SERVICE BULLETIN

AIR - ENGINE - DEDICATED ALTERNATOR - COOLING AIR SUPPLY - CATEGORY CODE 5 -
MOD.ENG-75-0010

ENGINE DEDICATED ALTERNATOR-STATOR
UNIT. INTRODUCTION OF AIR COOLING
TO ALTERNATOR STATOR.

Location of dedicated alternator (stator)
Fig.1

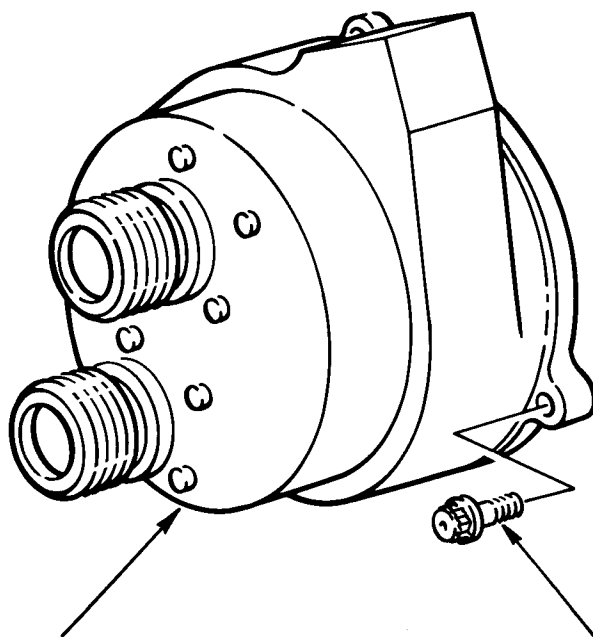
REMOVE PMA1664 Mk2 AND
INSTALL PMA1664 Mk3

REMOVE 4P0153 BOLTS (3 off) AND
INSTALL AS32218 BOLTS (3 off)

- (1) Remove the engine dedicated alternator (E.D.A.) stator 1664 Mk2 as instructed in the Aircraft Maintenance Manual, TASK 73-22-38-000-010.
- (2) Disconnect the nut connecting tube 6A2135 to the fan exit pressure boss 5A9518, remove the bolts 4W0107 (3 off) securing the fan exit pressure boss to the fan case (refer to Figure 13) and remove the fan exit pressure boss.

View sharing air cooling tubes and clipping points - After alteration
Fig.2

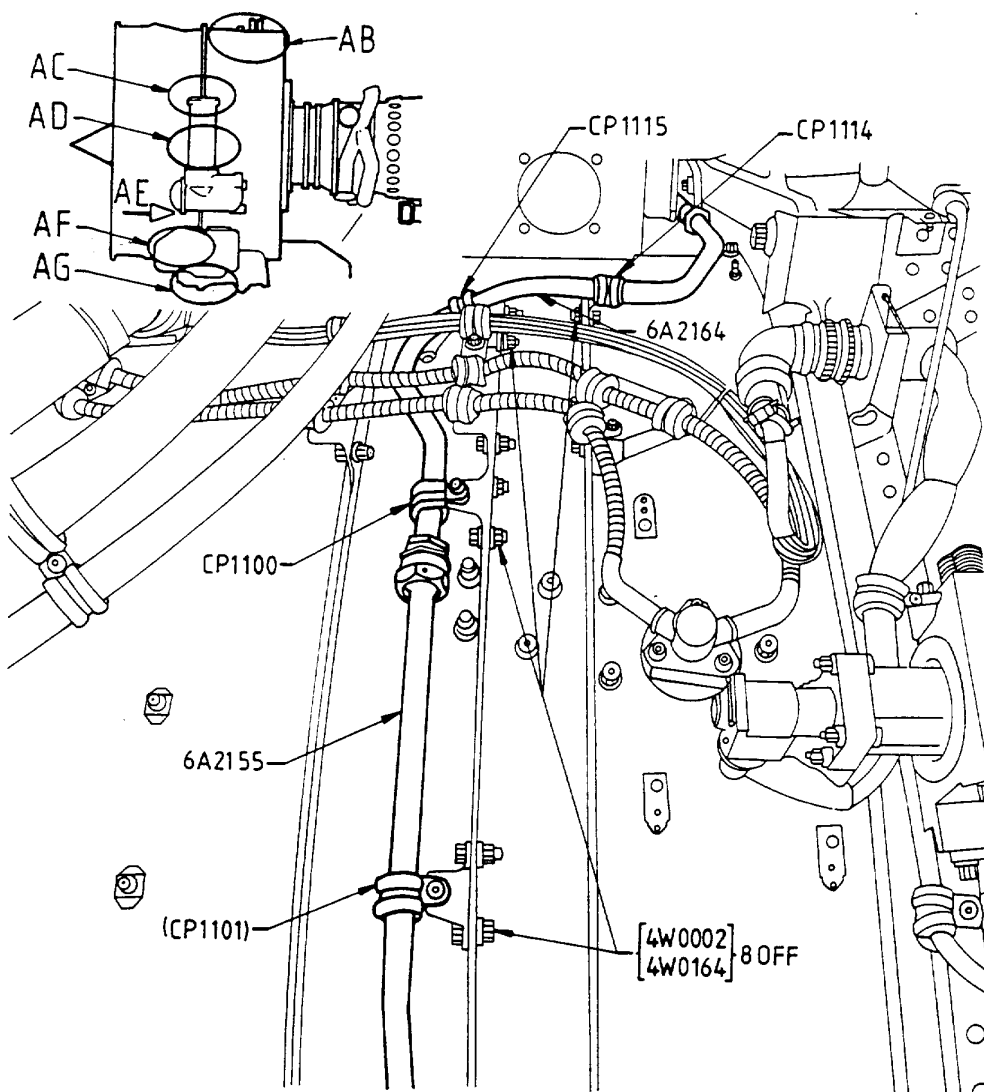
- (1) Install and secure the new fan exit pressure boss 5A0413 and connect the tube 6A2135 (refer to Figure 13).
- (2) Install the tube 6A2164; support at CP1114, CP1115 and CP1100 (refer to Figures 2 and 3) and connect to the exit pressure boss.

- (3) Install the tube 6A2155; support at CP1101 and CP1102 (refer to Figures 2, 4 and 5) and connect to tube 6A2164.
- (4) Install the tube 6A2157; support at CP1103, CP0853, CP0852 and CP0851 (refer to Figures 4, 5, 6 and 7) and connect to tube 6A2155.

Clipping points - Before and after alteration
Fig.5

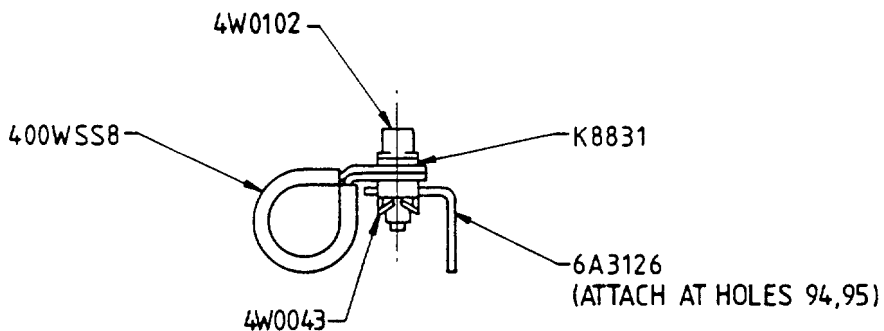
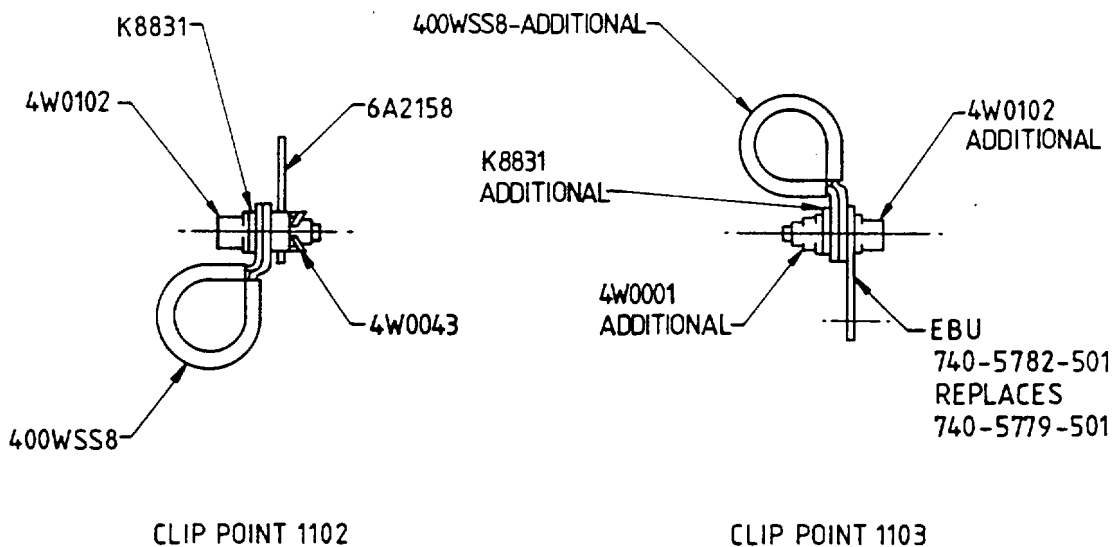
CLIP POINT 1101
AFTER ALTERATION

Clipping points - Before and after alteration
Fig.7

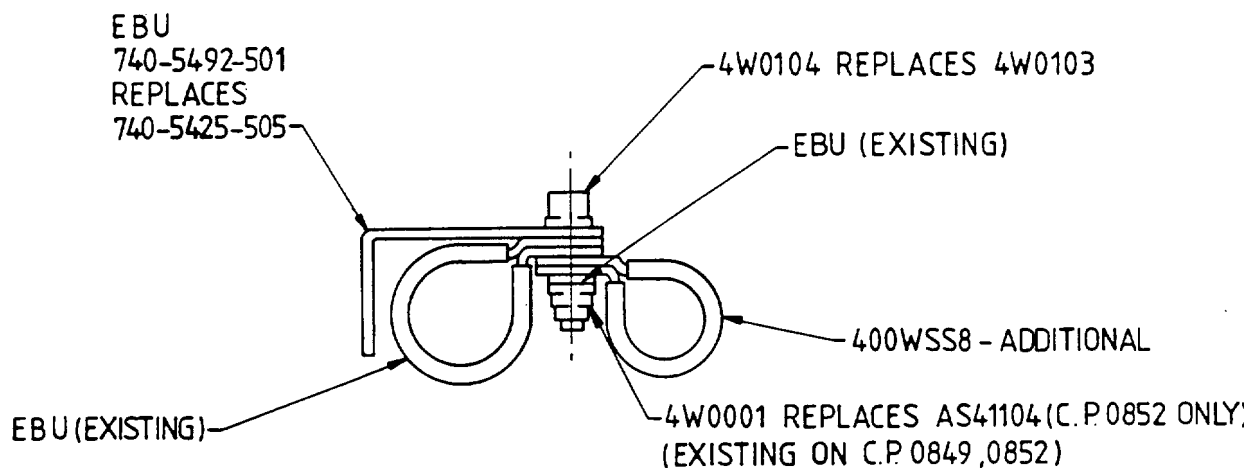
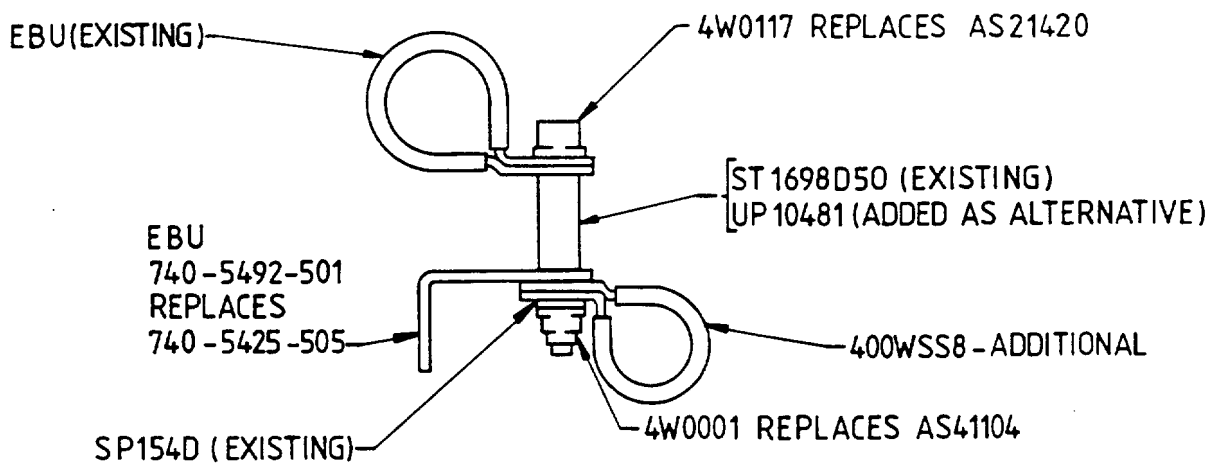
CLIP POINTS 0849 0851 & 0852
BEFORE AND AFTER ALTERATION

CLIP POINT 0853

- (5) Install the tube 6A2156; support at CP0849, CP0893, CP0847, CP0846, CP0845 and CP0779 (refer to Figures 7, 8, 9, 10 and 11) and connect to tube 6A2157.

Clipping points - Before and after alteration
Fig.11

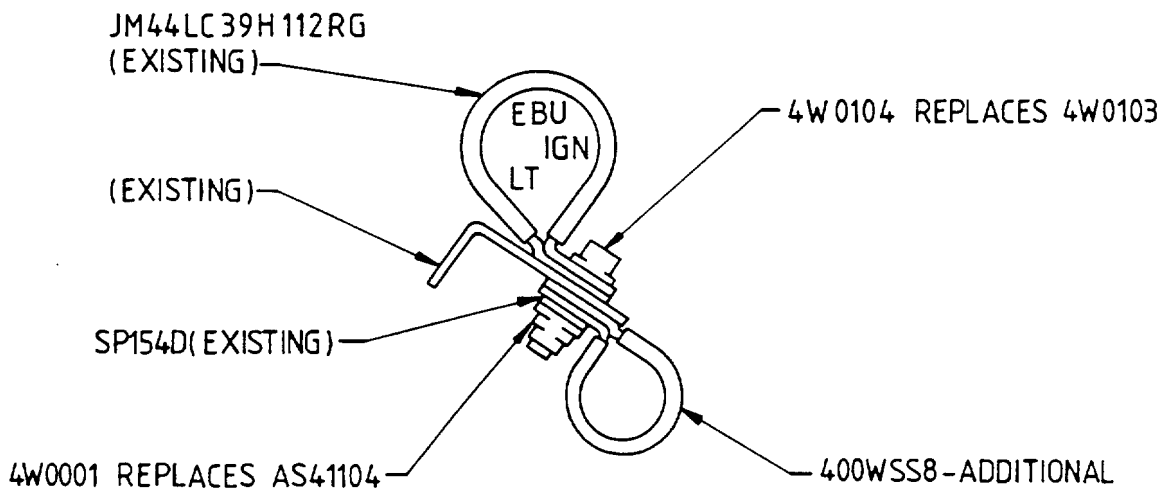
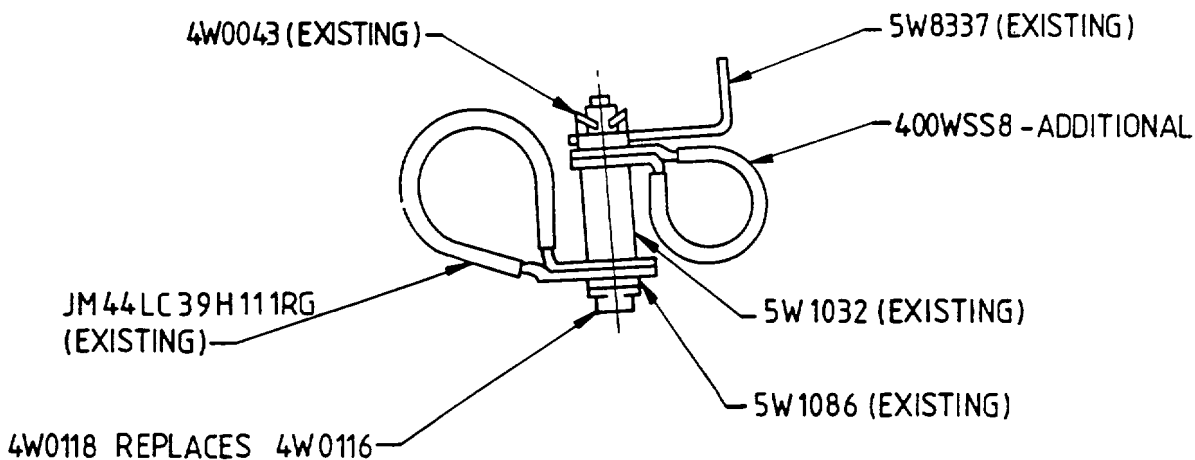
CLIP POINT 0845
BEFORE AND AFTER ALTERATION

CLIP POINT 0779

View showing the dedicated alternator - Before and after alteration
Fig.12

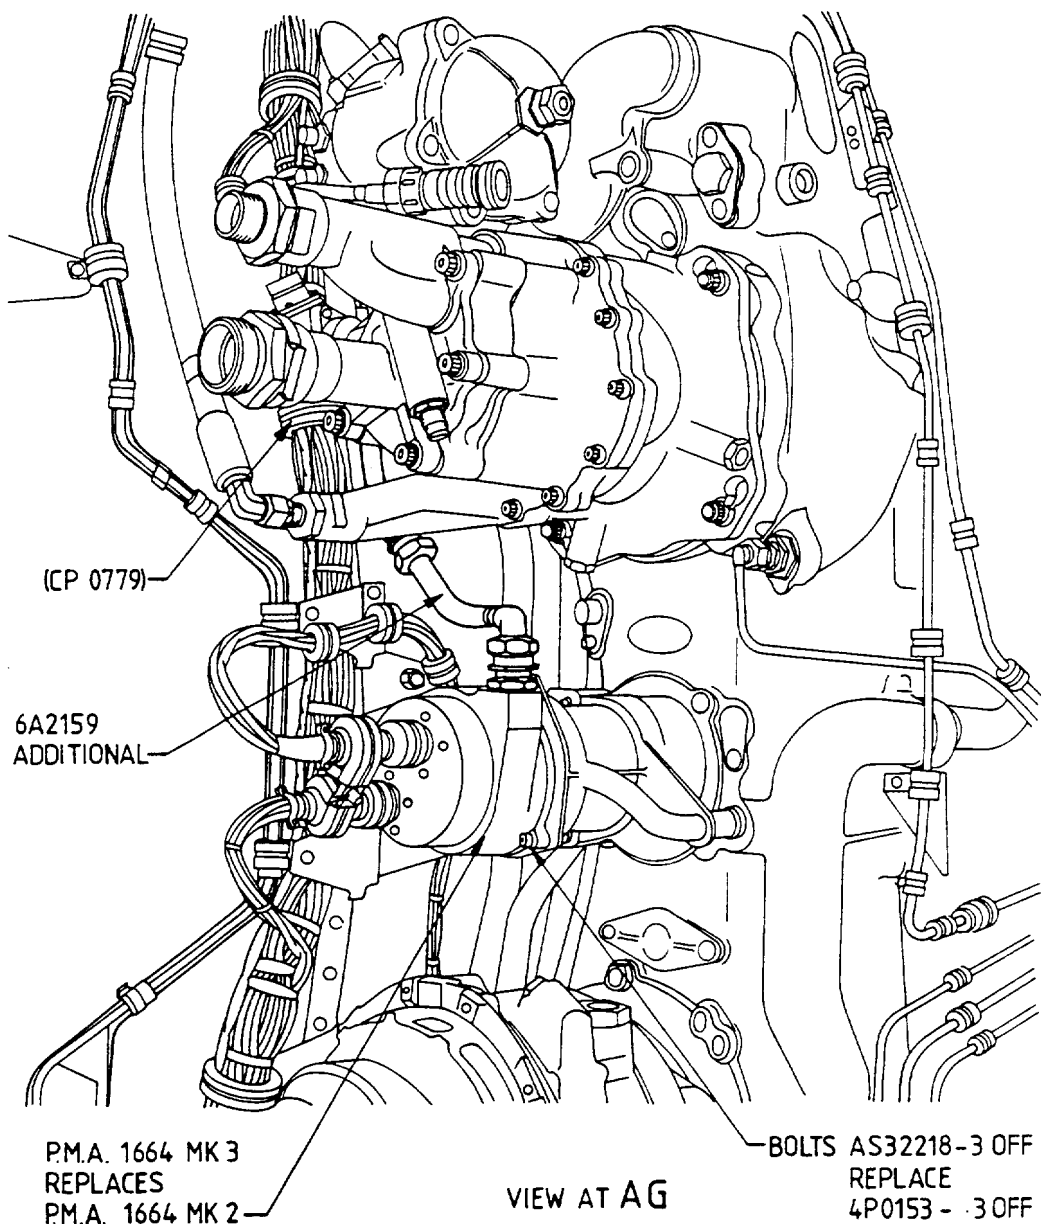
- (6) Install the tube 6A2159 (refer to Figure 12) and connect to tube 6A2156.
- (7) Install the engine dedicated alternator stator 1664 Mk3 as instructed in the Aircraft Maintenance Manual, TASK 73-22-38-400-010 and connect tube 6A2159 (refer to Figure 12).

Assembly of the Cooling Shroud
Figure 1

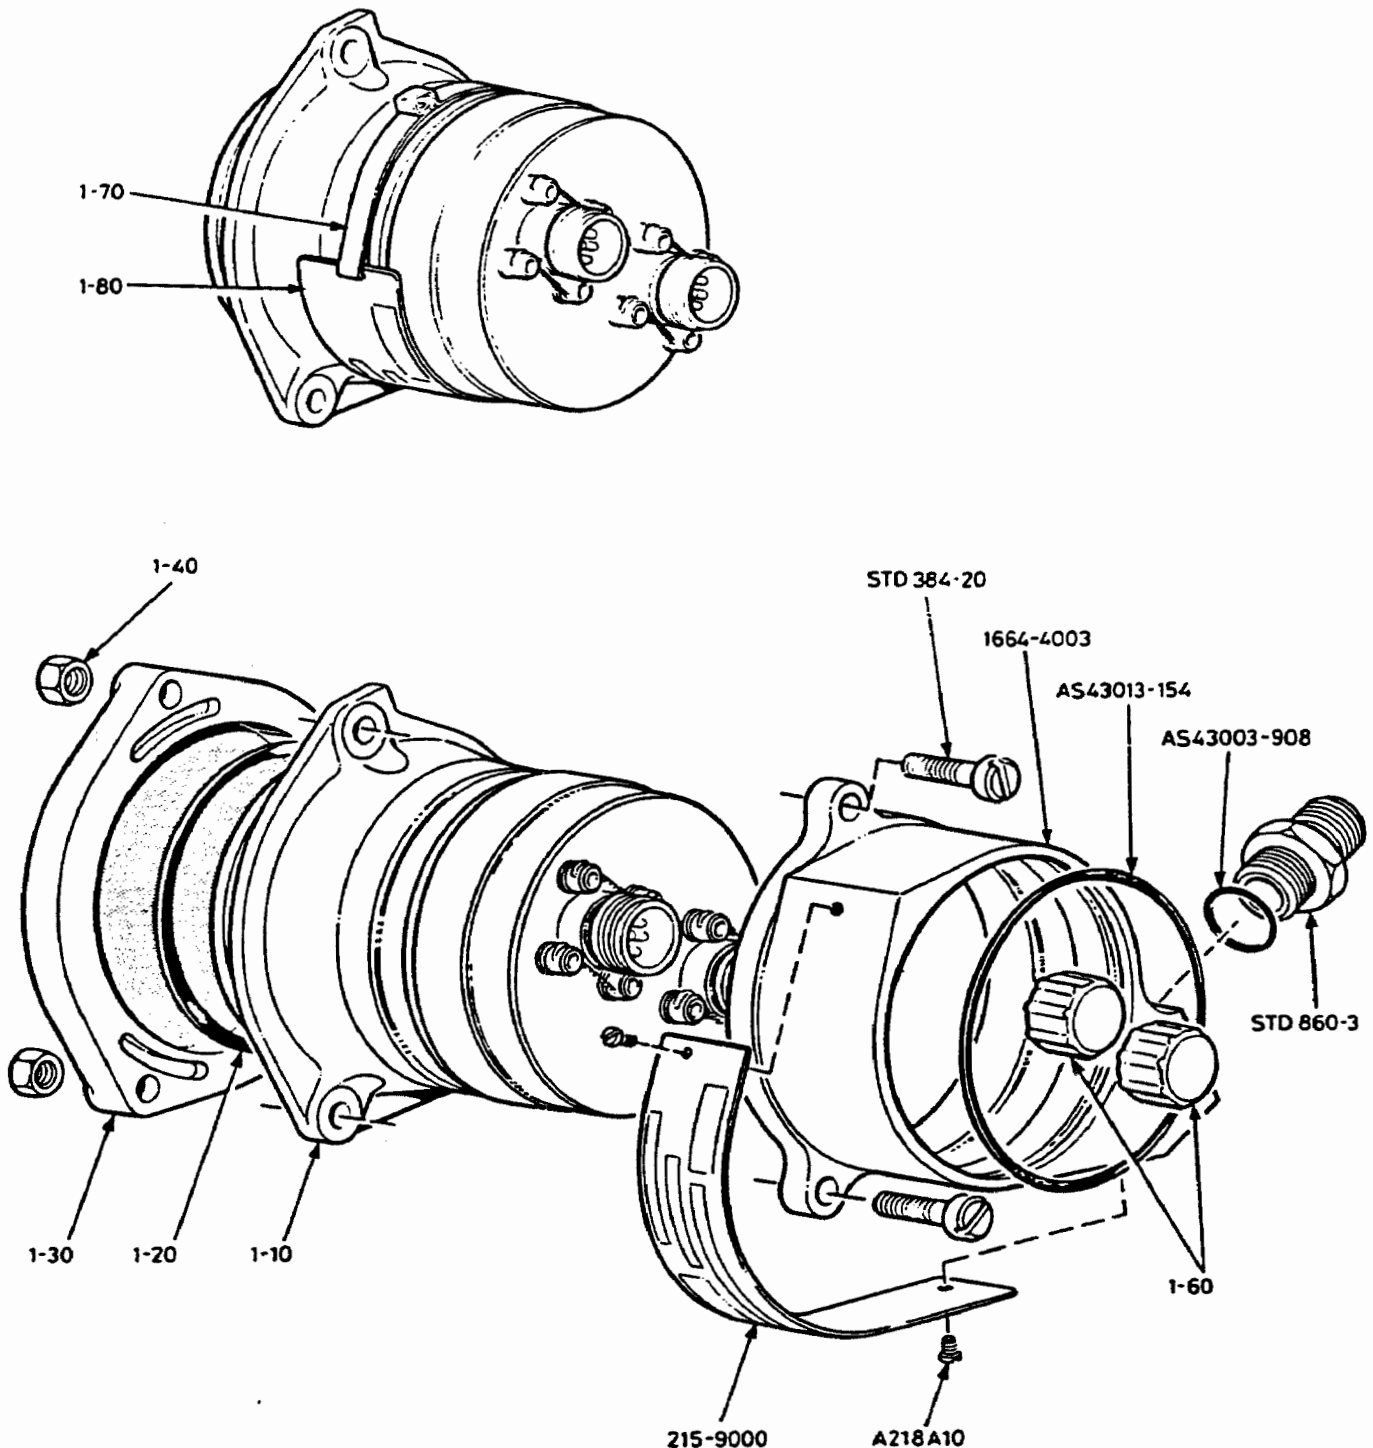
- (1) This Service Bulletin (Modification) introduces an aluminium shroud over the existing Stator Unit body. Air is supplied tangentially into the shroud, flows over the body and is then vented through a gap between the shroud and the body.
- (2) Control of the air flow is by a choke orifice at the inlet to the shroud. The air flow helps heat movement from the body and causes a winding temperature of less than 215°C.
- (3) This Service Bulletin is in two parts. Part 1 is to accomplish this Service Bulletin on-wing. Part 2 is to accomplish this Service Bulletin by unit replacement.

- (1) Remove the Engine Dedicated Alternator (EDA), Stator Unit as instructed by IAE Service Bulletin V2500-ENG-75-0010.
- (2) Refer to 73-22-38 and Figure 1 of this Service Bulletin and release the bonding strip (1-70); remove the bonding strip (1-70) and the identification plate (1-80) from the stator unit.

- (6) Install the toroidal sealing ring (AS43013-154) into the groove inside the shroud and inserts assembly.
- (7) Assemble the shroud and inserts assembly (1664-4003) over the body of the stator unit (1-10). Align the holes in the flange of the shroud and inserts assembly with the holes in the flange of the stator unit body.
